UNITED STATES PATENT AND TRADEMARK OFFICE

APPLICATION NO.	FILING DATE	FIRST NAMED INVENTOR	ATTORNEY DOCKET NO.	CONFIRMATION NO.
10/771,284	02/05/2004	Richard Assaker	64118.000046	3238

Office Action Summary

DETAILED ACTION

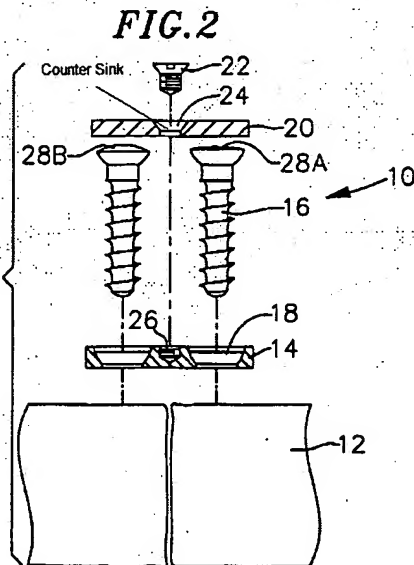
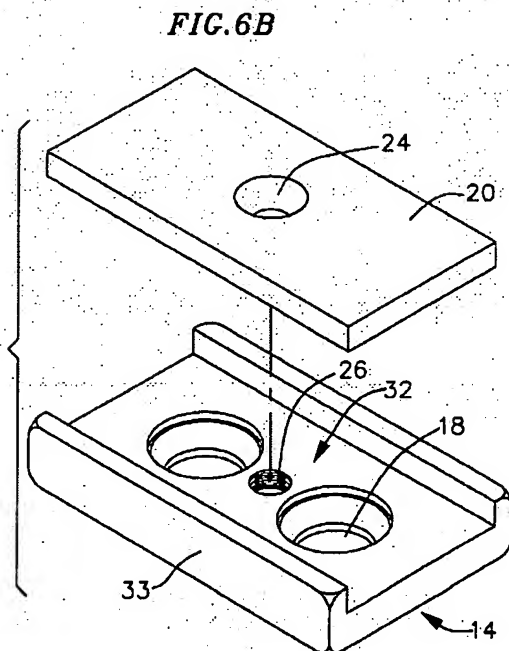
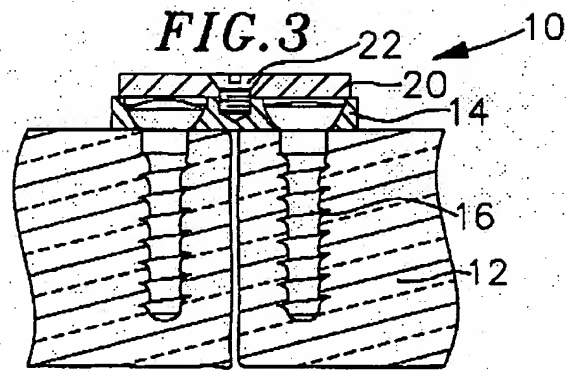
Bray discloses a bone plate assembly comprising: a fixation plate (14, Fig. 2 below) having a longitudinal axis along the plate, a locking plate (20, Fig. 2), and a bone fastener (16, Fig. 2) wherein the fixation plate is capable of being fixed by at least the bone fastener to a bone, and wherein the locking plate is capable of being secured to the fixation plate and is longitudinally adjustable along the longitudinal axis from a first position wherein the bone fastener can be fixed to the bone to a second position in which the bone fastener is locked into position by the locking plate. The locking plate could be slid back from the screw aperture (18, Fig. 2) (or even completely out of the hole), and the bone fastener can be placed through the screw aperture and placed into the bone. This can be considered the first position. The plate can then be slid back over the screw aperture and the locking plate can be locked. This can be considered the second position. The locking plate is capable of only limited vertical and longitudinal freedom relative to the fixation plate. When the screw is placed through the hole (24, Fig. 2) in the locking plate and is partially engaged with the screw aperture, the plate would still be able to move up and down relative to the plate and there would still be some play between the screw and the locking plate in the "longitudinal" direction. The longitudinal freedom is defined by a sliding connection between the locking plate and the fixation plate. The locking plate is able to slide relative to the fixation plate. The fixation plate has a bottom surface, which faces the bone, and a top surface spaced therefrom (Fig. 2), and the sliding connection is formed by providing opposing shoulders

(33, Fig. 6B below) in the top surface of the fixation plate so as to define a guide way (32, Fig. 6B) for the locking plate. The vertical freedom is defined by a lock screw (22, Fig. 2), which extends through an opening (24, Fig. 2) in the locking plate to secure the locking plate to the fixation plate. The distance between the first position and the second position defines a longitudinal play and the opening in the locking plate is a slot (24, Fig. 2) having a first end opposing a second end which together define the longitudinal play of the locking plate relative to the fixation plate. The locking plate has an exterior surface (Fig. 2) and the slot includes a counter sink (Figs. 2 and 3 below). The locking plate has an exterior surface (Fig. 2) and the slot includes a counter sink (Fig. 2 below), and the lock screw is capable of sinking substantially flush with the exterior surface of the locking plate (Fig. 3 below). The lock screw extends through a hole in the fixation plate (24, Fig. 2), and further has means to restrain it from exiting the threaded hole of the fixation plate. The means can be considered the threads of the bone screw, and the head of the screw, which frictionally engages the opening in the locking plate. The locking plate can simultaneously lock multiple bone fasteners into position. The plate can lock at least two in position, as seen in Fig. 6B. The bone fasteners are screws (28B and 28A, Fig. 2). At least two bone fasteners (28B and 28A, Fig. 2) are included and the locking plate and can simultaneously lock all the bone fasteners of the fixation plate. The plate can lock both screws at the same time when the locking plate is locked into position. A plurality of bone fasteners (28B and 28A, Fig. 2) are used in the bone plate assembly, and all of the bone fasteners of the fixation plate are aligned to enable them to be locked by the locking plate. Two points form a line, and the two screws are in

two points in the plate, hence they are aligned. They are capable of being locked into the plate at the same time, as already discussed. The two screws are in alignment. The locking plate includes at least one opening (24, Fig. 2) which is capable of accepting a bone fastener, and which is further capable of being concentrically aligned with at least one opening for a bone fastener in the fixation plate when the locking plate is in a first position. The holes could be placed one above the other in the first position, before the locking plate is locked in the second position. Bray further discloses an implant for the spine, comprising: a plate for stabilizing the spine (14, Fig. 2), the plate having a number of openings (18, Fig. 2); a number of bone anchorage screws (28B and 28A, Fig. 2) each capable of engaging a corresponding one of the openings of the plate; and means for blocking the screws including at least one slide (20, Fig. 6B) which can be mounted on the plate to selectively cover at least a part of at least one of the screws. When the locking plate (20, Fig. 6B) engages the fixation plate (14, Fig. 6B), the plate can cover the top of the screws. Bray discloses means for retaining the slide on at least one of the screws, which is the lock screw (22, Fig. 2) along with the threaded hole (26, Fig. 6A) of the fixation plate. The slide is capable of cooperating with the retaining means, since the slide has a hole (24, Fig. 2). The plate defines a cavity (32, Fig. 6A) and the slide is capable of being mounted within the cavity (Fig. 3).

FIG. 8

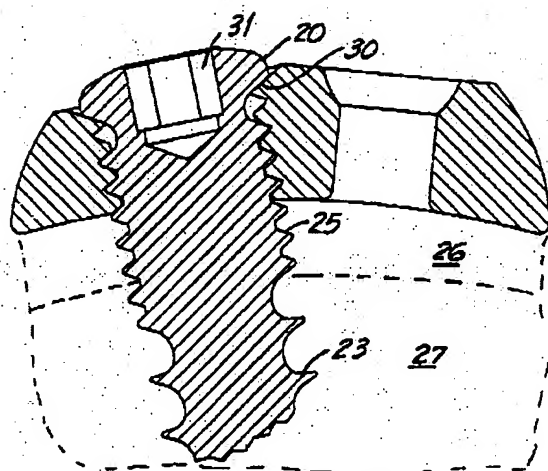
Trebing et al. disclose a locking plate having a threaded bore (30, Fig. 8 below), used for engaging the screw head to prevent back out (column 1, lines 35-39).

It would have been obvious to a person having ordinary skill in the art at the time the invention was made to have modified the locking plate of Bray with the threaded bore of Trebing et al, in order to better secure the screw to the plate (column 1, lines 35-39).
